11th May 2007
Ref: 1377

Mr Roger Bennion,
Planning Department,
Flintshire County Council,
County Hall
MOLD
CH7 6NF

**PARRY'S QUARRY ENVIRONMENTAL STATEMENT ADDENDA AND
RESPONSES TO CONSULTATIONS**

PARRYS QUARRY PROPOSED LANDFILL SITE

Figure 9. 98th Percentile Odour Concentration Contours, 2018

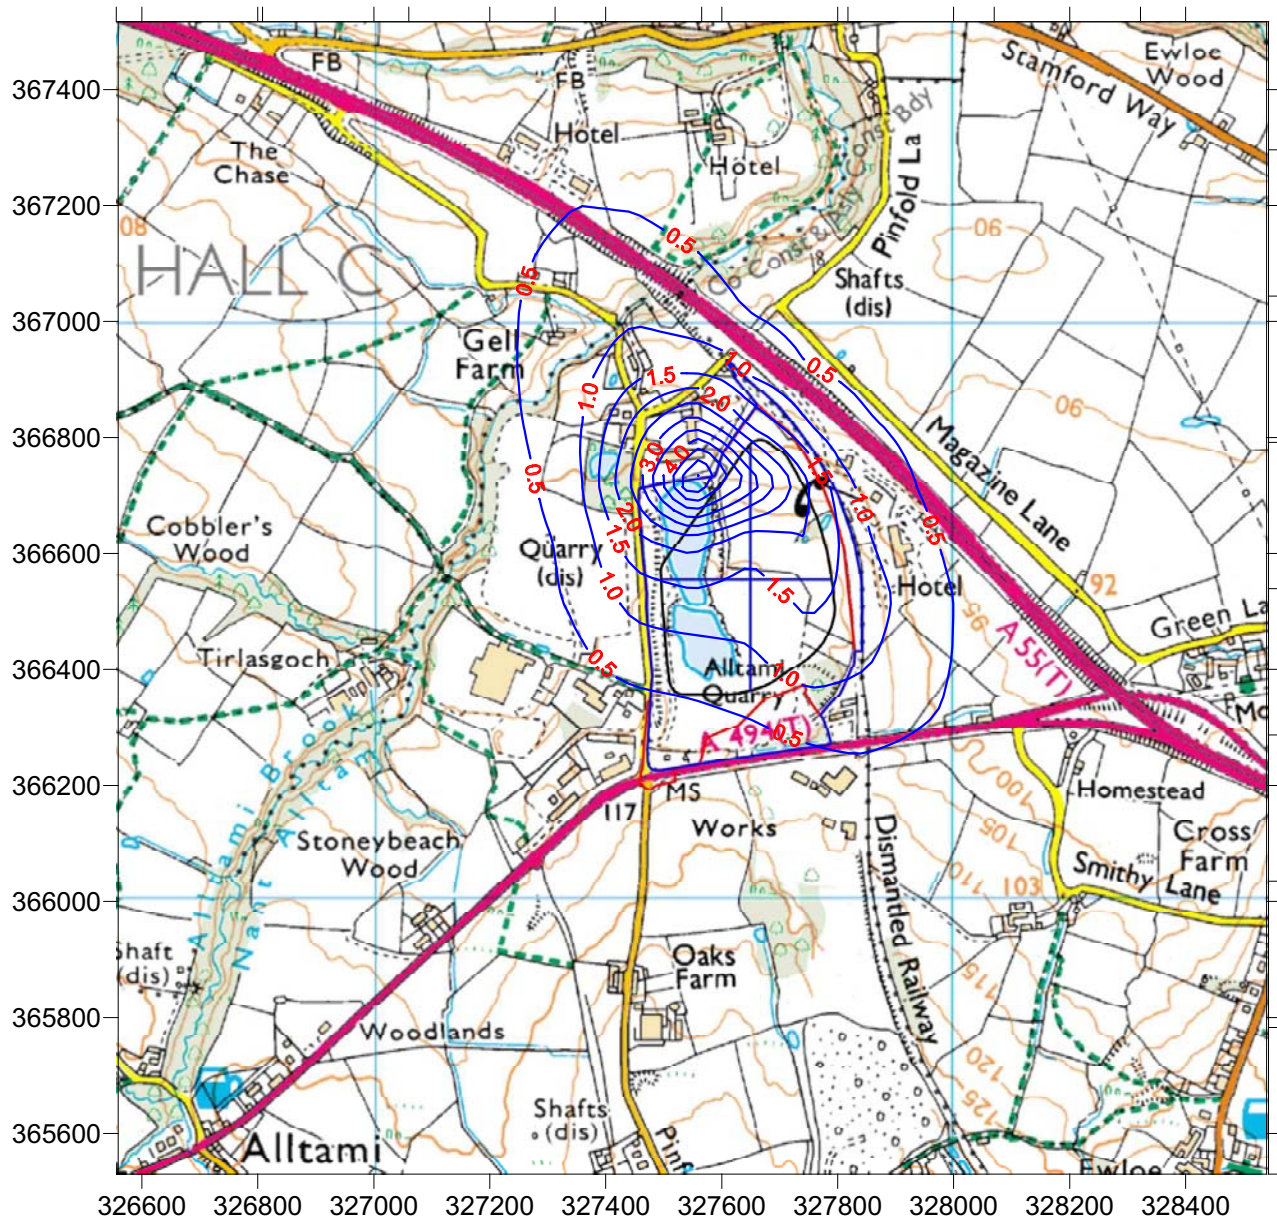
Predicted odour concentrations based on reasonable upper-bound (95th percentile) odour emission rates were below indicative criteria for all modelled years and all receptors, with the exception of the business/industrial area immediately to the north of the site, Alltami House and Penfold Cottage for the year 2018 (Table 4b). These three receptors are located to the north and north-west of the landfill, and their potential susceptibility reflects the predominance of south-easterly winds in the general area. Figure 9 shows a contour plot of the odour concentrations for the year 2018.
